2012 IOAP Project Modification

IOAP Programmatic Modification Summary

August 17, 2012 (Revised September 20, 2012)

Subject: 13th Street and Rowan Street Storage Basin
Minor Project Modification
IOAP Project No. L_OR_MF_155_M_09B_B_B_4
DOJ Case No. 90-5-1-1-08254

Integrated Overflow Abatement Plan
Vol. 3 - Sanitary Sewer Discharge Plan
Pond Creek Sewershed
Solution ID # S_PO_WC_PC09_M_09B_C
Outer Loop & Caven Ave Wet Weather Storage 3
Caven Ave. Wet Weather Storage

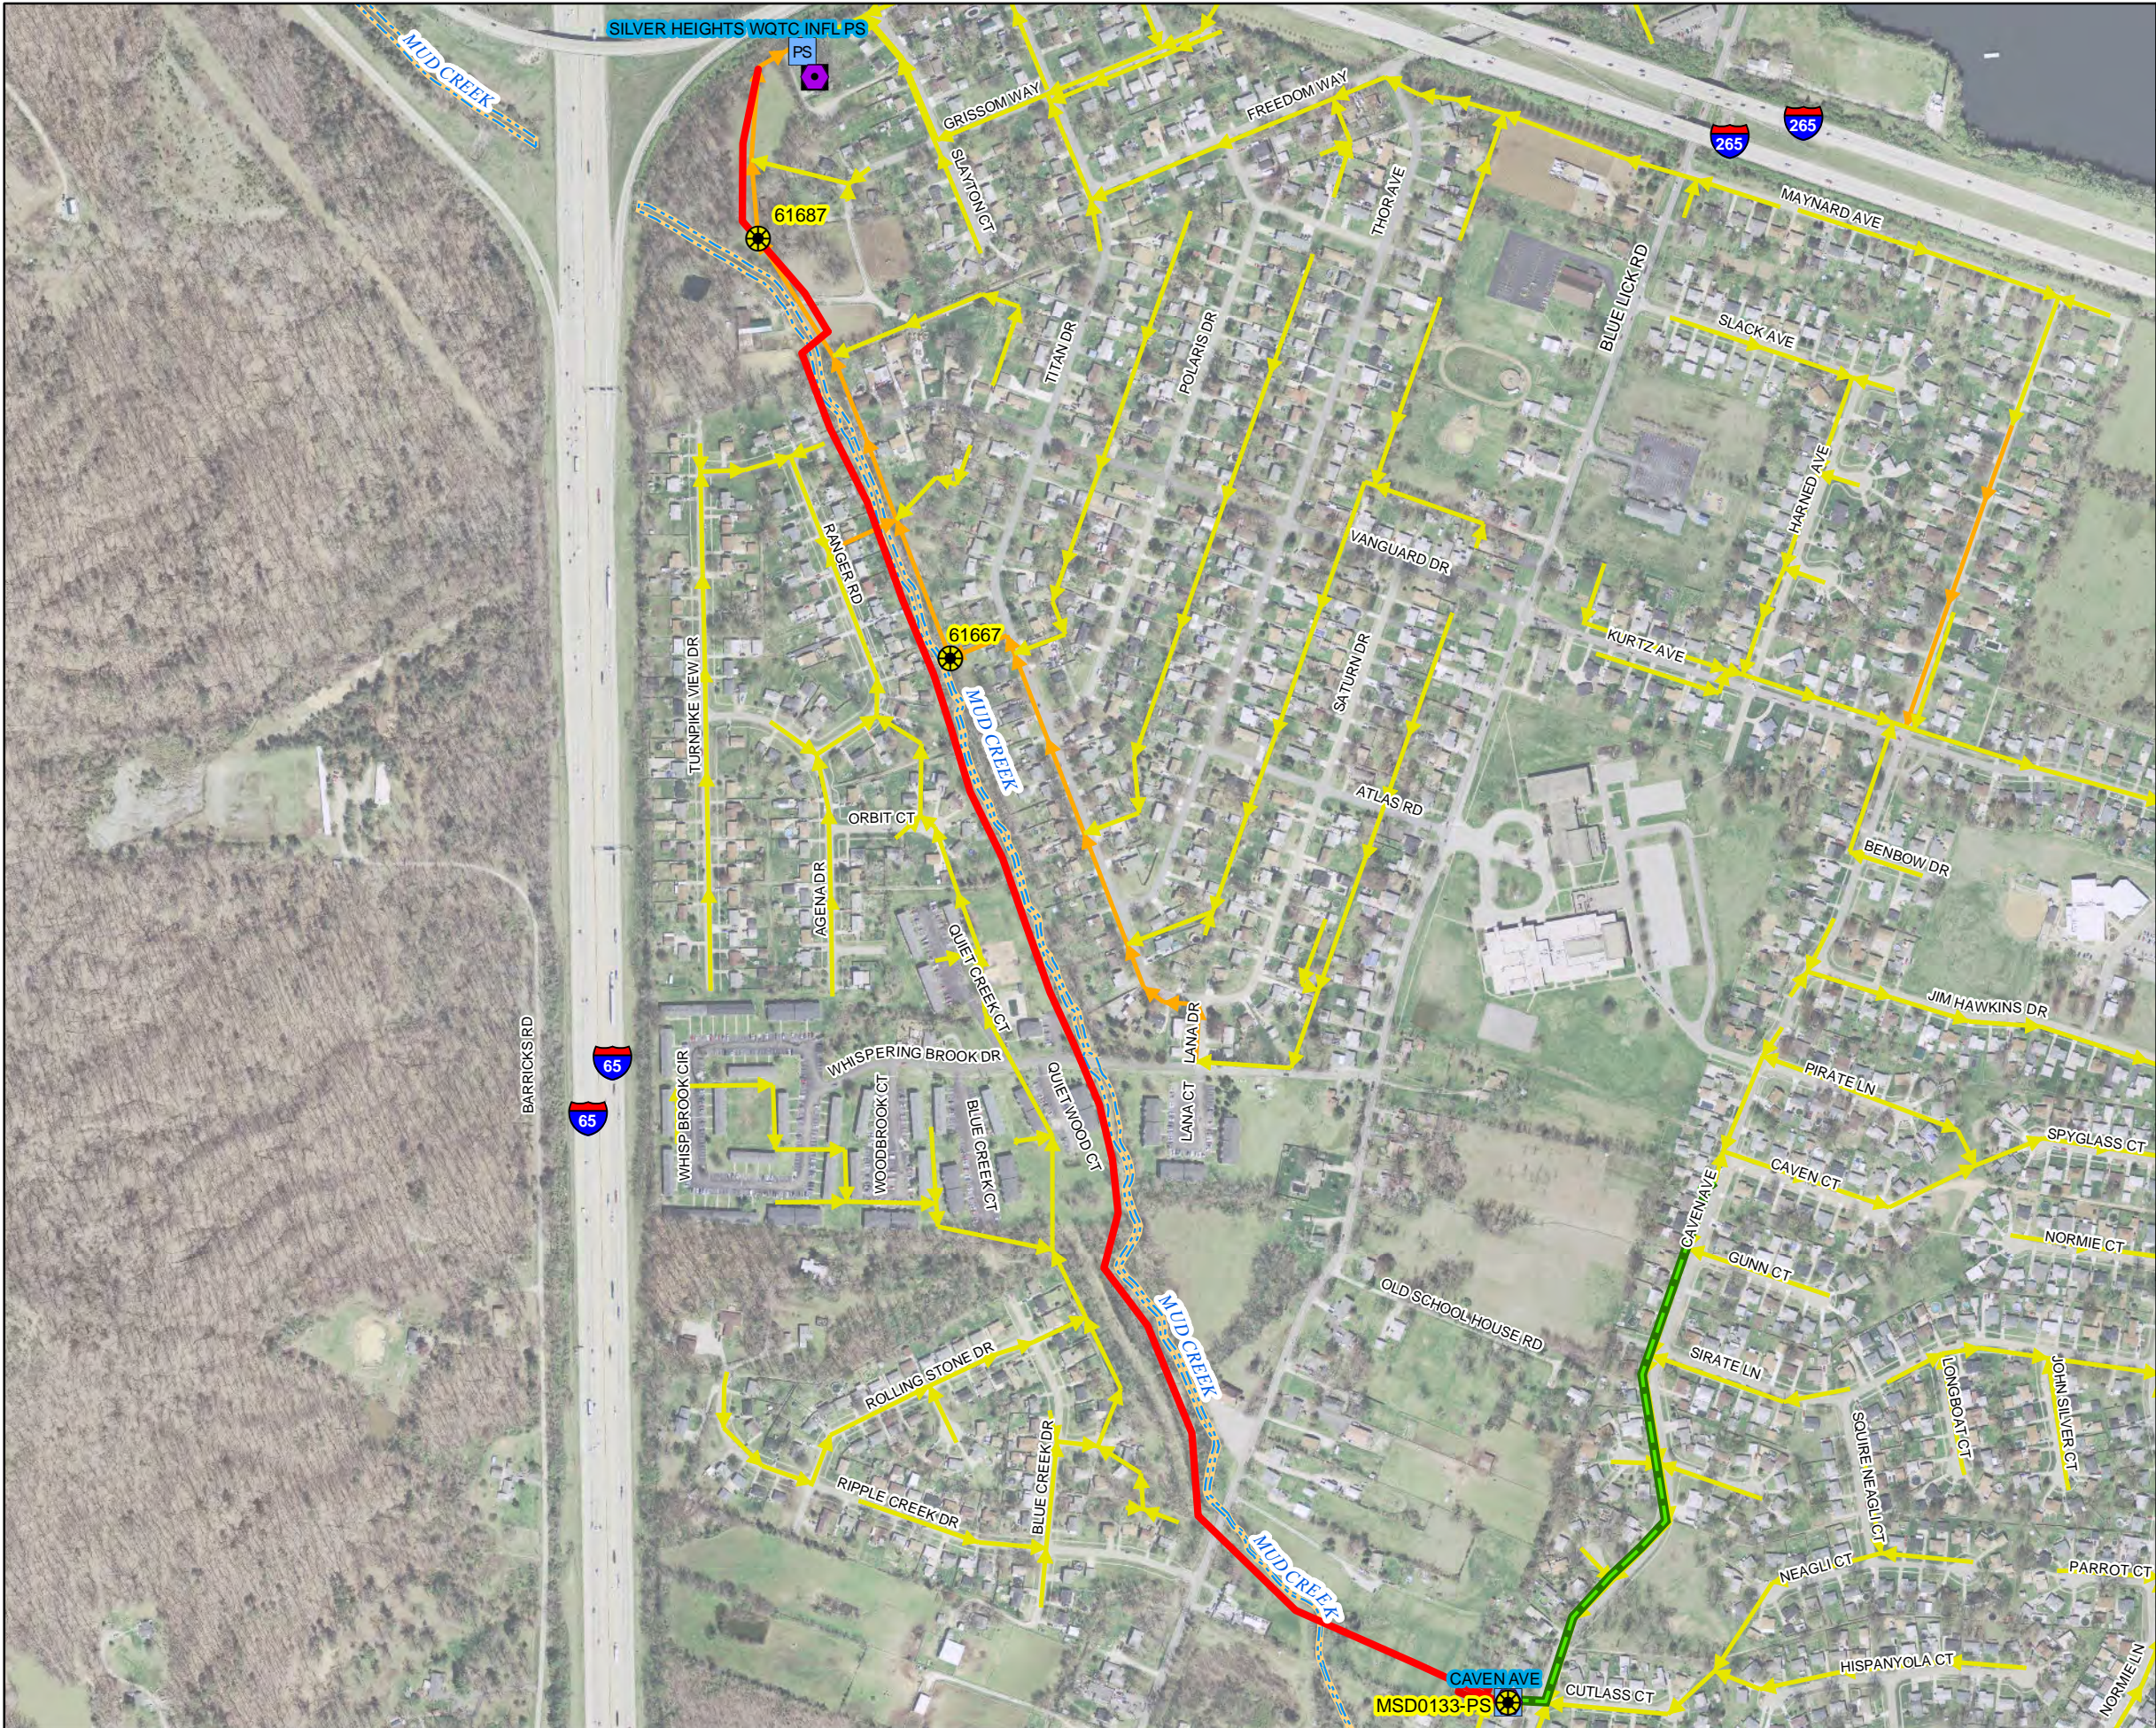
In 2012, the Mud Creek Interceptor Sanitary Project was added to MSD's capital plan to construct a 24-inch diameter gravity interceptor from the Silver Heights Water Quality Treatment Center (WQTC) to the Fishpool Interceptor. The project was initiated to eliminate the Silver Heights WQTC. The construction of this interceptor provides an alternative solution to eliminating SSOs at the Caven Ave Pump Station by diverting flows from the pump station to the Silver Heights WQTC system and eventually through the Mud Creek Interceptor, thus eliminating the Caven Ave Pump Station.

LTCP Project Number: L_MU_MF_154_M_09B_B_A_8

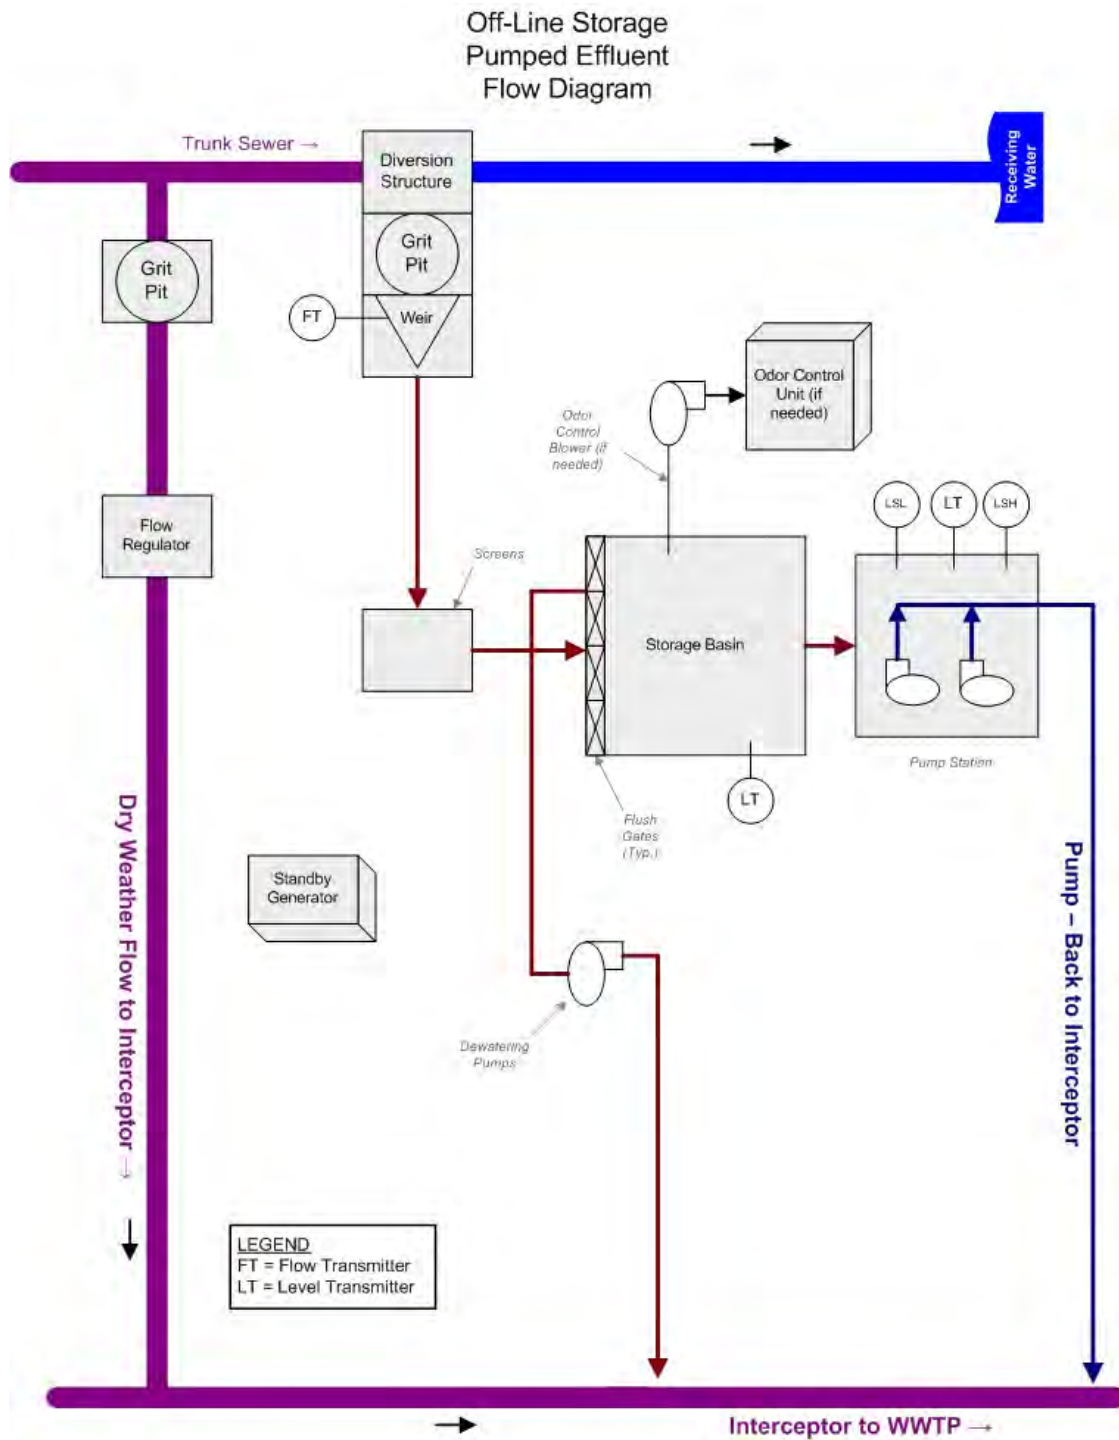
MSD proposes to change the Clifton Heights Storage Basin solution from a 6.55 MG basin to a 4.28 MG basin, and revise the level of control from eight overflows per typical year to four overflows per typical year.

Based on the results of the re-calibration, a level of control analysis was conducted on the Clifton Heights Storage Basin. The level of control analysis showed that the basin size of 4.28 MG would meet a level of control of four overflows per year and provide the highest benefit/cost ratio. Therefore, MSD proposes to change the Clifton Heights Storage Basin solution from a 6.55 MG basin to a 4.28 MG basin. These improvements will maintain the same completion date of December 31, 2018, as the original solution.
